RESPONSE TO REQUEST FOR ADDITIONAL INFORMATION

APR1400 Design Certification

Docket No. 52-046

RAI No.: 357-8344
SRP Section: 06.02.04 – Containment Isolation System
Application Section: 6.2.4
Date of RAI Issue: 01/05/2016

Figure 6.2.4-1 Containment Isolation Valve Arrangement (Sheet 9 of 13)

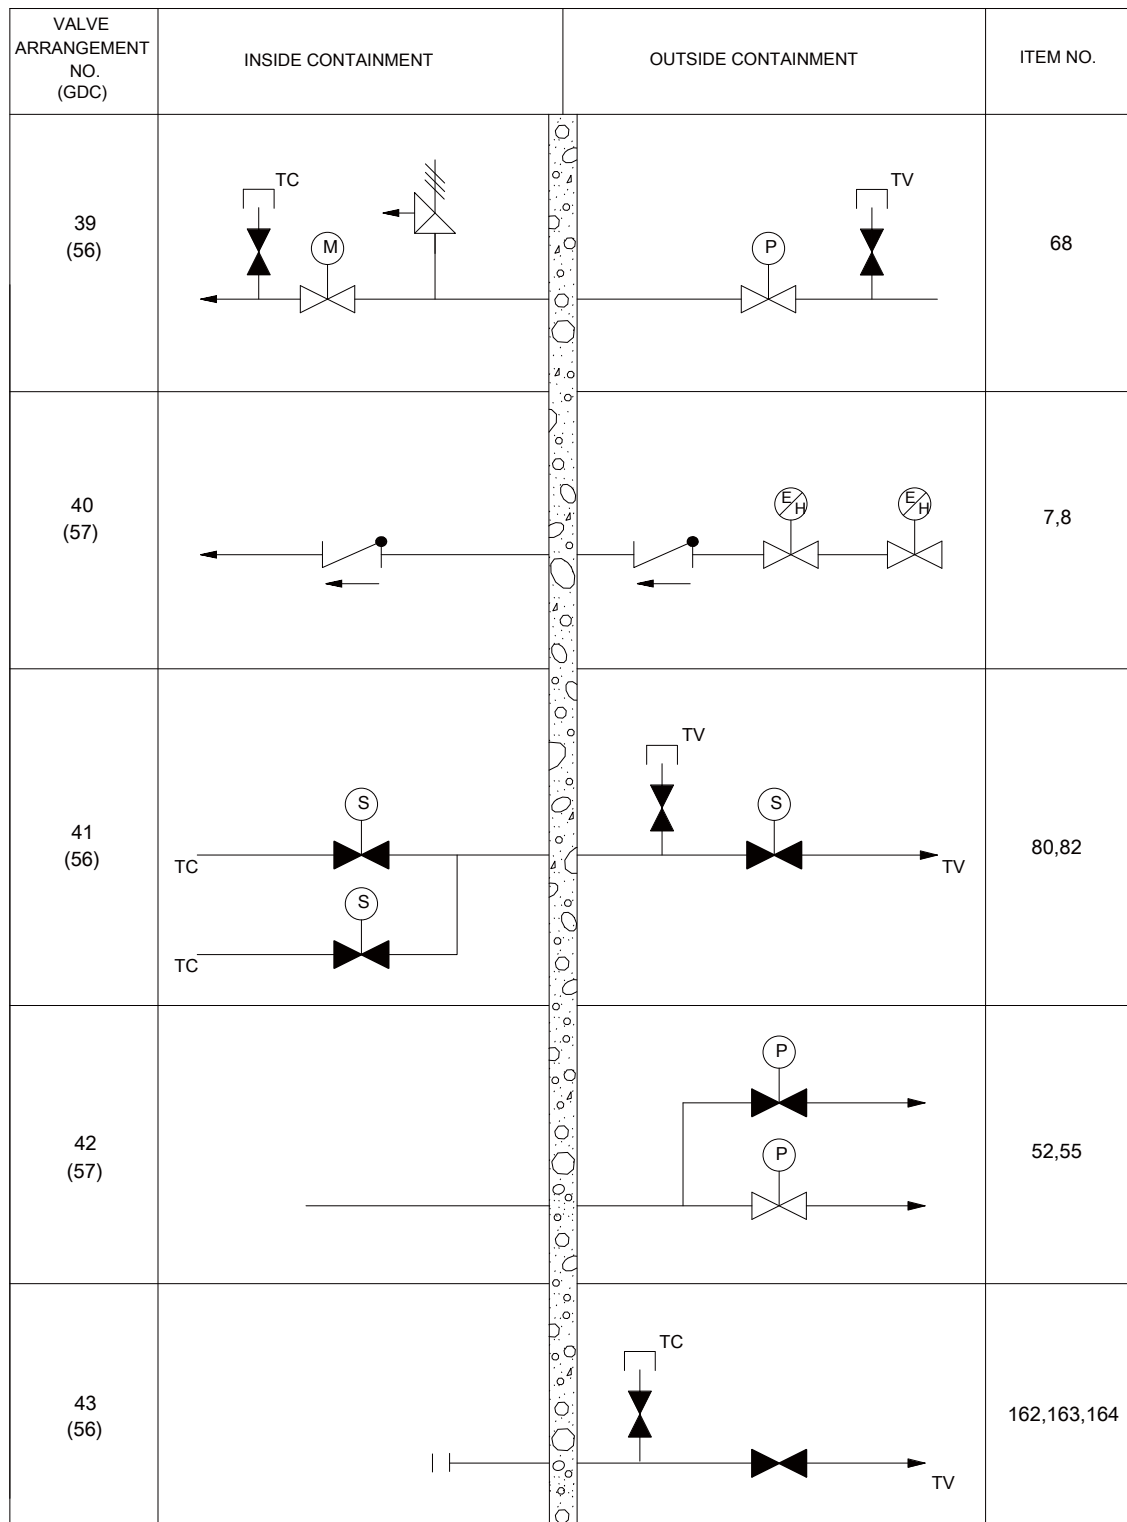
Provide a table describing the provisions for individual leakage rate testing of the isolation barrier.

In order to evaluate if requirements of General Design Criteria (GDC) 54, as it relates to the ability to test the operability of isolation barriers, are met and to determine if valve leakage is within acceptable limits, for each containment isolation barrier, provide a table in the DCD describing the provisions (test connection etc.) for individual leakage rate testing of the barrier.

DCD Tier 2, Figure 6.2.4-1 will be revised to include the leak rate test connections and locations for associated valves, vents, and drain connections along with the locations of the applicable CIVs. Table 6.2.4-1 contains a list of all containment isolation valves (CIVs) including a designation of the test type for each individual valve. Table 6.2.4-1 also includes reference to the valve arrangements depicted in Figure 6.2.4-1. A detailed discussion regarding the Type C test is presented in DCD Tier 2, Subsection 6.2.6.3. The replacement figures provided in Attachment 1 delineate the test connections for the individual CIVs for leakage measurement. This was determined to be a more appropriate means of depicting the associated test connections; a separate table also describing the test connections would be redundant and is considered unnecessary.

DCD Tier 2, Figure 6.2.4-1 and DCD Tier 1, Figure 2.11.3-1 will be revised, as indicated in the attachments associated with this response.

- DCD Tier 2, Figure 6.2.4-1 (Attachment 1)
